2. CASE 20.037, 535 BROADWAY, House, ca1880 (BROADWAY)

Overall Proposal: The scope of work proposed consists of Demolition and New Construction and includes:

The applicant is requesting the demolition of the existing detached 1950 concrete-block garage.

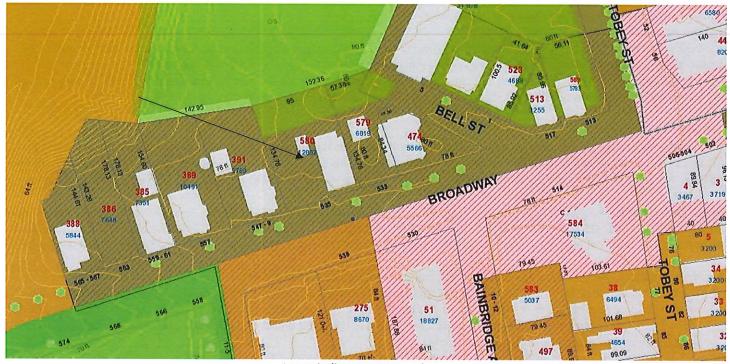
The building proposed for demolition is a secondary, non-contributing structure with minimal architectural or historical merit. The cinder-block, one-story building at 535 Broadway is identified within the Broadway/Armory National Register Historic District as a non-contributing structure. Staff was able to located a building record file with a build date of September 18, 1950. The removal of the building will not irreparably diminish the architectural or historical character of the district as a whole.

Staff is satisfied that given the minimal architectural, there are no alternatives to demolition because no reasonable expectation exists that the structure can be sold for preservation either on or off site. Staff recommends that the documentation requirements relative to demolition alternatives and financial information for the garage be waived as it pertains to a non-contributing structure.

Staff finds the building slated for demolition to be a secondary structure and would use the PHDC's secondary criteria for approving demolition. This proposal meets these criteria, in that it will have little effect on surrounding buildings or on the district as a whole.

- a) The 1950 cinder-block, one-story building at 535 Broadway is a non-contributing structure and has minimal to no historical and architectural significance, both on its own merit and in relation to the surrounding Broadway local historic district. The removal of the building is consistent with the non-contributing criteria of the PHDC demolition guidelines, in that it would have little impact on the property and the district as a whole;

- b) The application for demolition is complete. The PHDC waives the requirement for documenting financial information relative to the demolition, because the building slated for demolition is a non-contributing structure;

- c) The PHDC is satisfied that there are no alternatives to demolition because no reasonable expectation exists that the secondary structure can be sold for preservation either on or off site;

- d) The review of the proposed demolition is hereby completed in one meeting, as allowed for secondary and non-contributing structures under the PHDC demolition guidelines; and,

- e) The work as proposed is in accord with PHDC Standard 8 in the following way: the work will be done so that it does not destroy the historic character of the property or the district.
